LR-N99556  
LCR S99-11

**REQUEST FOR CHANGE TO TECHNICAL SPECIFICATIONS  
REACTOR TRIP SYSTEM INSTRUMENTATION  
SALEM GENERATING STATION  
UNIT NOS. 1 AND 2  
DOCKET NOS. 50-272 AND 50-311**

**SALEM GENERATING STATION  
UNIT NOS. 1 AND 2  
FACILITY OPERATING LICENSES DPR - 70 AND DRP - 75  
DOCKET NOS. 50-272 AND 50-311  
CHANGE TO TECHNICAL SPECIFICATIONS**

**TECHNICAL SPECIFICATION PAGES WITH PROPOSED CHANGES**

TABLE 2.2-1 (Continued)

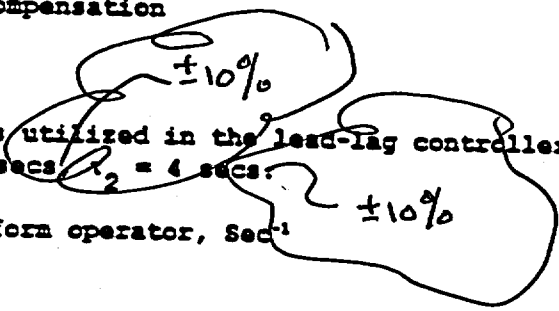
The following changes, shown in underlined bold, should be incorporated on the attached marked up pages.

$\tau_1$  &  $\tau_2$  = Time constants utilized in the lead-lag controller for  $T_{avg}$   $\tau_1 = 30$  secs,  $\tau_2 = 4$  secs.

$\tau_1$  &  $\tau_2$  = Time constants utilized in the lead-lag controller for  $T_{avg}$   
 $\tau_1 = 30 \text{ secs } \underline{\pm 10\%}$ ,  $\tau_2 = 4 \text{ secs } . \underline{\pm 10\%}$
